Additional C9 Report to Authority

A report in accordance with Standard Condition C9 for 2025-2026.

2.05 Balancing Services for Inclusion in ABSVD (Non-BMU)

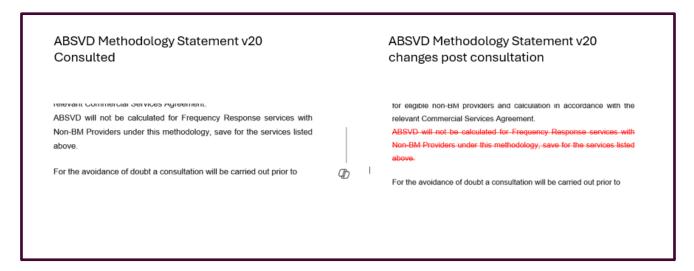
NESO have proposed deleting the note above as it is superfluous with the potential to cause confusion to industry as there is an inconsistency between the non-BM ABSVD applied table and the notes below.

The table "Non-BM ABSVD Applied" clearly outlines the Applicable Balancing Services contracts with Non-BM Providers that will be included in the ABSVD calculation, and it is this table that industry should use.

The notes below the table are designed to add clarity rather than re-state information that is already found in the table.
